Core Operating Limits Report

LaSalle County Station

Unit 1, Reload 4 (Cycle 5)

ISSUANCE OF CHANGES SUMMARY

Figure 2.2-1

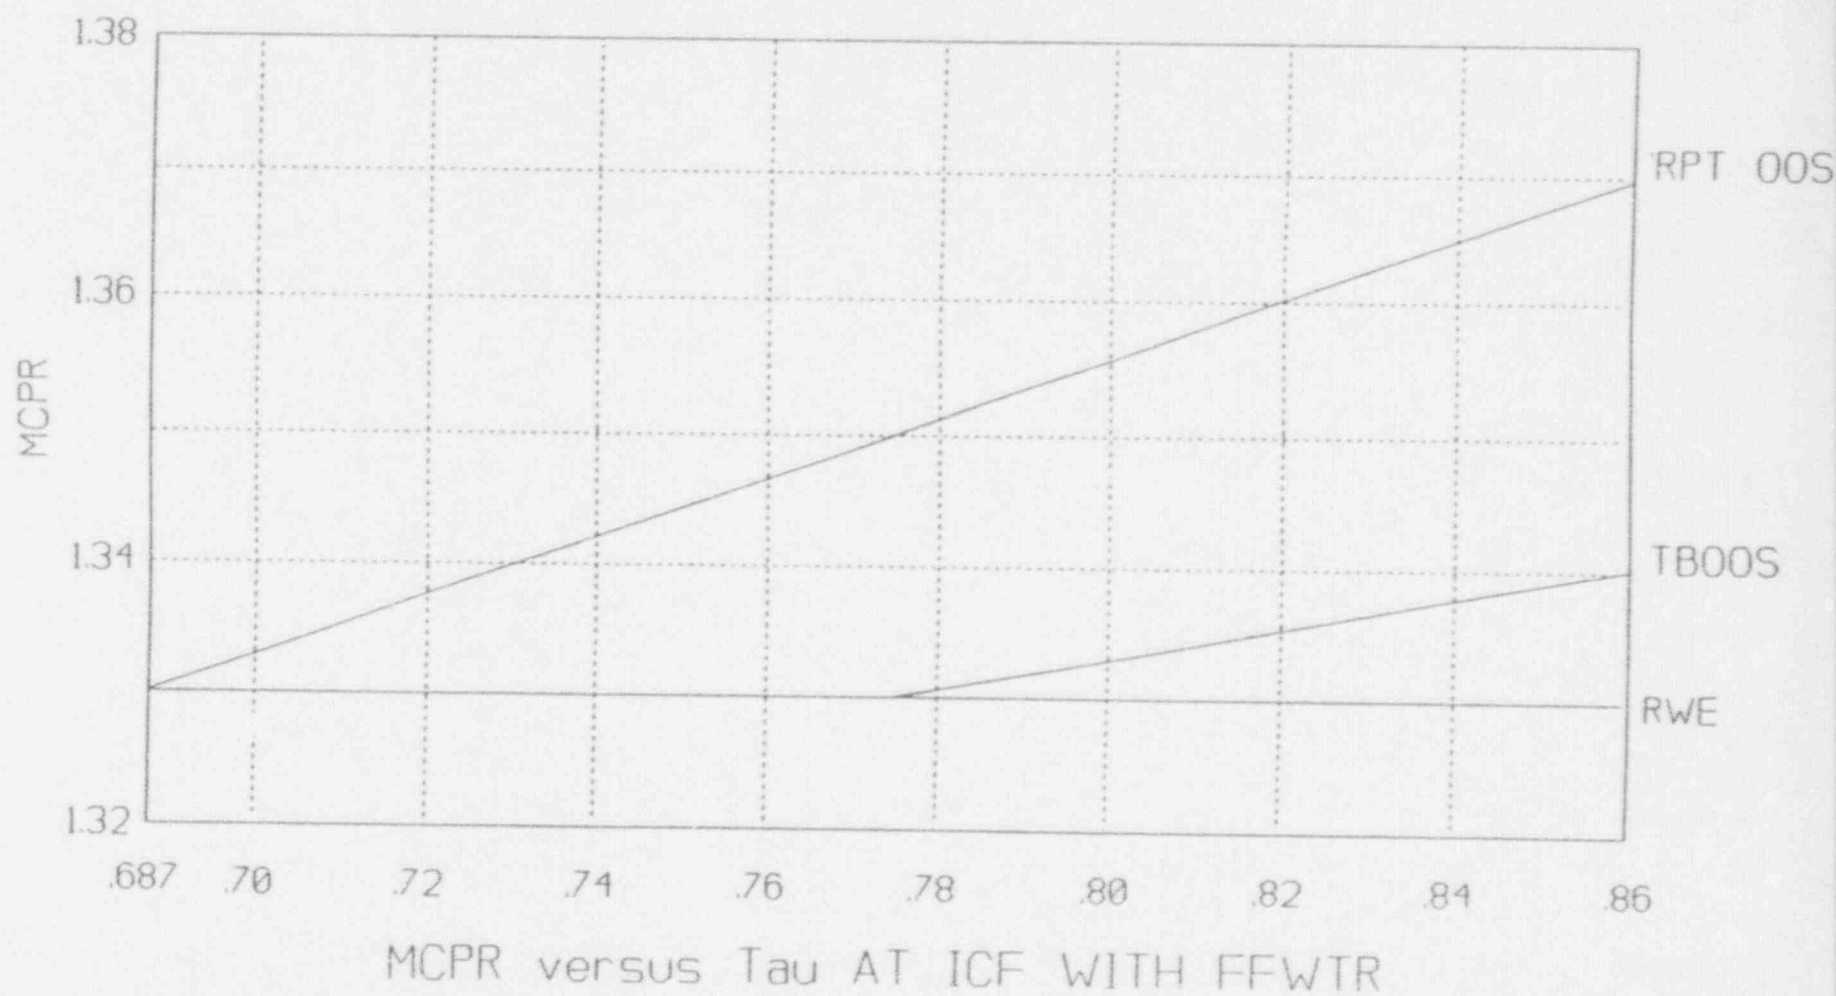
Affected Section	Affected Pages	Summary of Changes	Date
All	All	Original Issue (Cycle 4)	12/89
All	All	Original Issue (Cycle 5)	4/91
References	iii	References for new EOOS Analysis	3/92
List of Figures	iv	Revised Title/Description for New EOOS Analysis	3/92
2.0	2-2	Revised MCPR Power Distribution Limits (all fuel types) for New EOOS Analysis	3/92

The MCPR limit when in Dual Recirculation Loop Operation is determined from Figure 2.2-1 times the Kf factor determined from Figure 2.2-2.

The MCPR limit when in Dual Recirculation Loop Operation with the Main Turbine Bypass Inoperable (per Tech Spec 3.7.10) is determined from Figure 2.2-1 times the Kf factor determined from Figure 2.2-2.

The MCPR limit when in Dual Recirculation Loop Operation with the End-of-Cycle Recirculation Pump Trip System (RPT) Inoperable (per Tech Spec 3.3.4.2) is determined from Figure 2.2-1 times the Kf factor determined from Figure 2.2-2.

The MCPR limit when in Single Recirculation Loop Operation is determined from Figure 2.2-1 plus 0.01, times the Kf factor determined from Figure 2.2-2.
